13 January 2023

Re: Fort Street Public School: SSD 10340, Section 4.55 Modification 2

Figure 1: Lift location in Building M, as per approved Design stamped 7 October 2020.

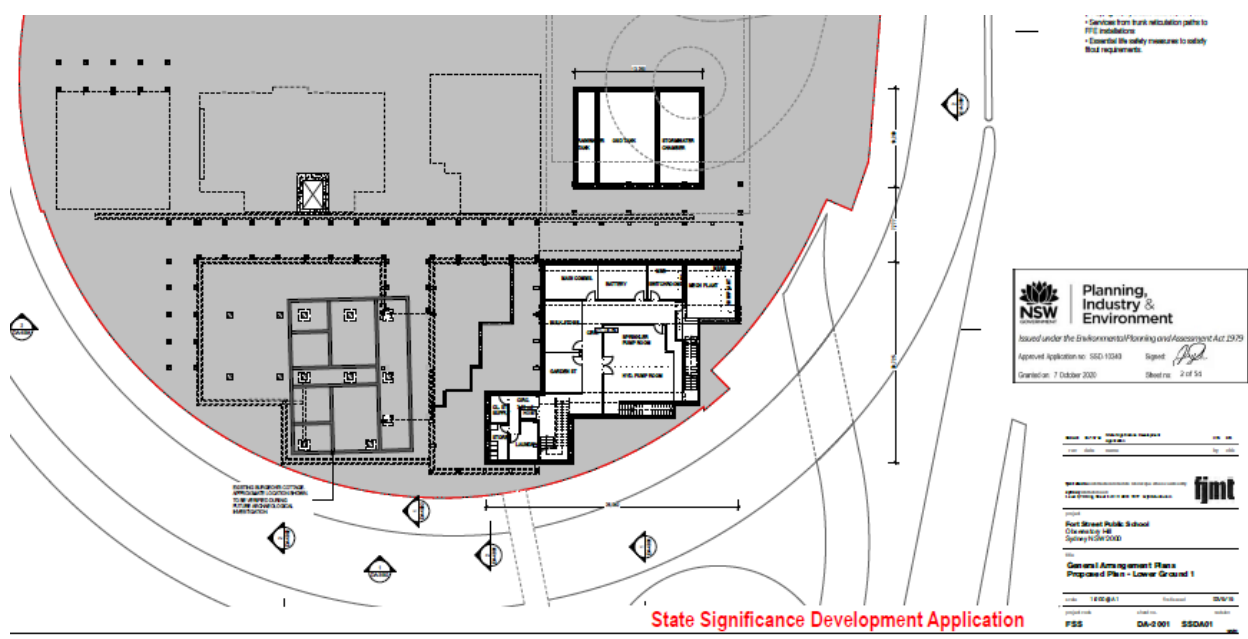
The installation of a lift has similarly been one of the major considerations in terms of access and compliance, and presumably has been subject to much design and engineering consideration. To alter this proposal at this stage to increase the building height by 610mm (not an insignificant amount) is extraordinary.

On 7 October 2020, the plans for this project were approved. The stamped plans show a new lift in Building M, and the footings of Building J specifically designed to avoid significant archaeology:

Figure 2: Lift location in previous modification – now moved to be within Building J.

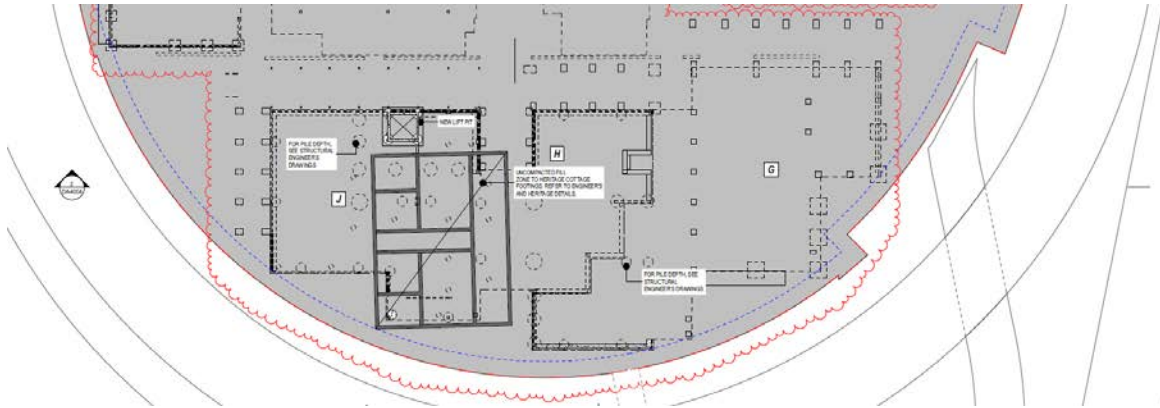
The Modification 1 design involved taking the lift out of Building M, and instead locating it within Building J. One of the main reasons given for this was to reduce the heritage impact on Building M. The lift shaft was also carefully positioned so as to avoid archaeological impact:

Modification 1 was submitted as an SSDA Modification, placed before the State Design Review Panel for interrogation, and subject to much (negative) community feedback. The final approved design was then substantially revised based on this feedback, with a key change being that the new lift location would have less heritage impact, particularly on Building M. There is nothing in the documentation associated with this Modification to show why this lift, as originally proposed, could not be executed as designed.

- How can a claim be made that the lift shaft cannot be lowered due to impacts on archaeology when it has previously (Mod 1) been specifically located to avoid such conflicts, and its position remains unchanged?
